CONTROLLED COPYPLANT SYSTEMSSURVEILLANCE REQUIREMENTS (Continued)e. Functional Tests

PLANT SYSTEMSSURVEILLANCE REQUIREMENTS (Continued)e. Functional Tests (Continued)

FIGURE 4.7-1
SAMPLE PLAN 2) FOR SNUBBER FUNCTIONAL TEST

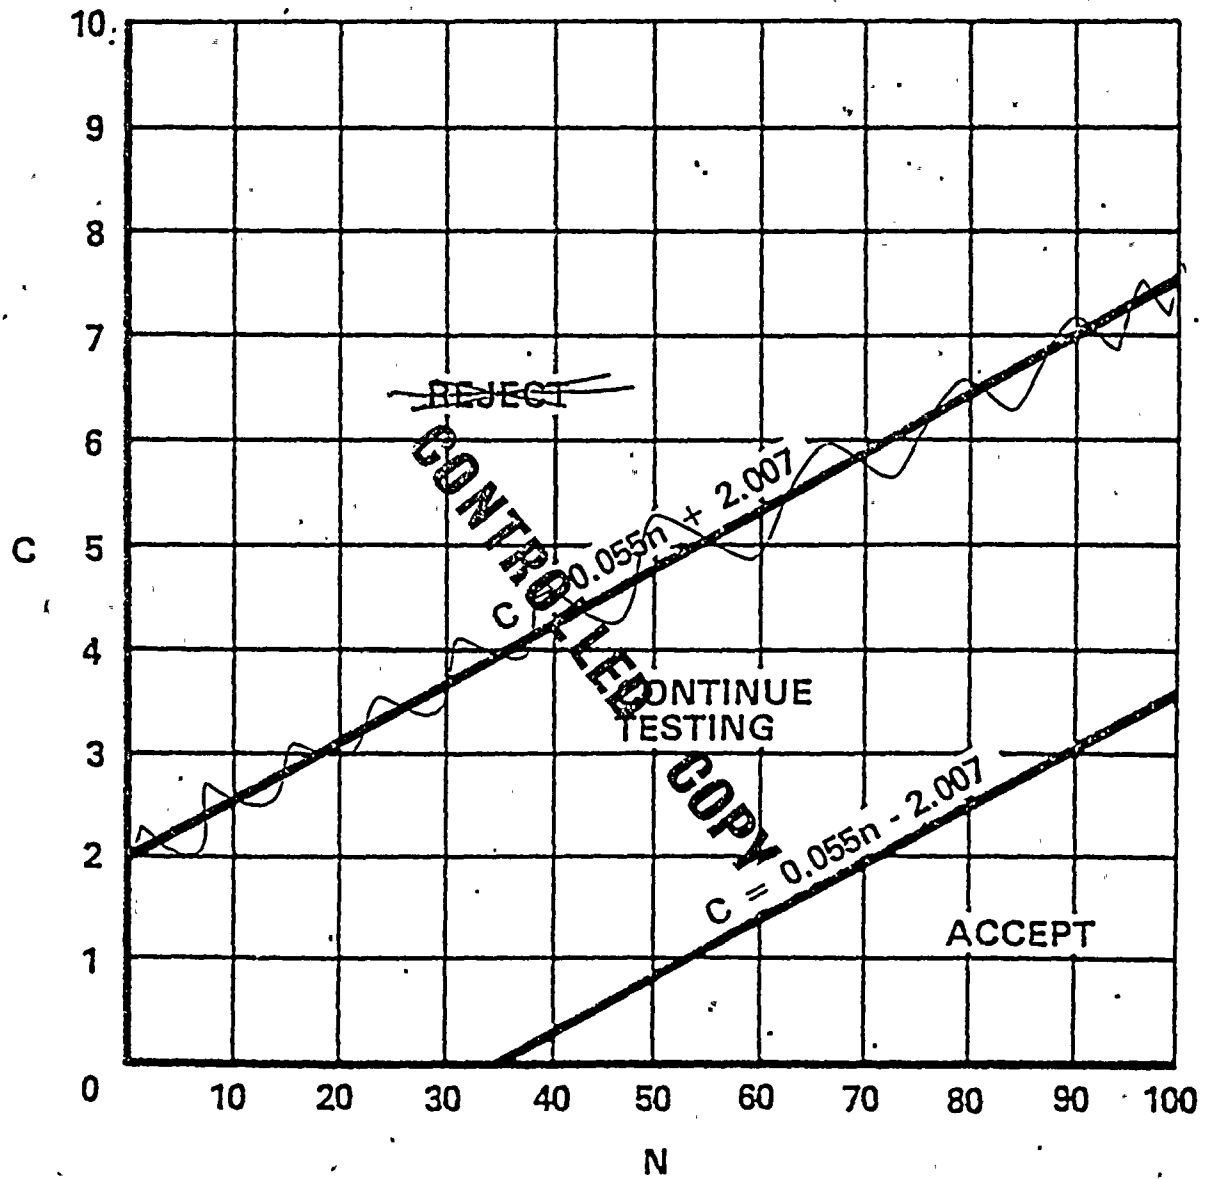
- 2) A representative sample of each ~~type of snubber~~ ³⁷ shall be functionally tested in accordance with Figure 4.7-1. "C" is the total number of snubbers of a type found not meeting the acceptance requirements of Specification 4.7.4f. The cumulative number of snubbers of a type tested is denoted by "N". ~~At the end of each day's testing, the new values of "N" and "C" (previous day's total plus current day's increments) shall be plotted on Figure 4.7-1. If at any time the point plotted falls in the "Reject" region, all snubbers of that type shall be functionally tested. If at any time the point plotted falls in the "Accept" region, testing of snubbers of that type may be terminated. When the point plotted lies in the "Continue Testing" region, additional snubbers of that type shall be tested until the point falls in the "Accept" region or the "Reject" region, or all the snubbers of that type have been tested. Testing equipment failure during functional testing may invalidate that day's testing and allow that day's testing to resume anew at a later time provided all snubbers tested with the failed equipment during the day of equipment failure are retested, or~~

1. Functionally test 10% of a type of snubber with an additional ~~10%~~ ^{5%} tested for each functional testing failure, or
2. Functionally test a sample size and determine sample acceptance or continue testing* ~~rejection~~ using Figure 4.7-1~~x~~.

3. ~~Functionally test a representative sample size and determine sample acceptance or rejection using the stated equation.~~

To provide assurance of snubber functional reliability, one of ~~three~~ ^{two} functional testing methods are used with the stated acceptance criteria:
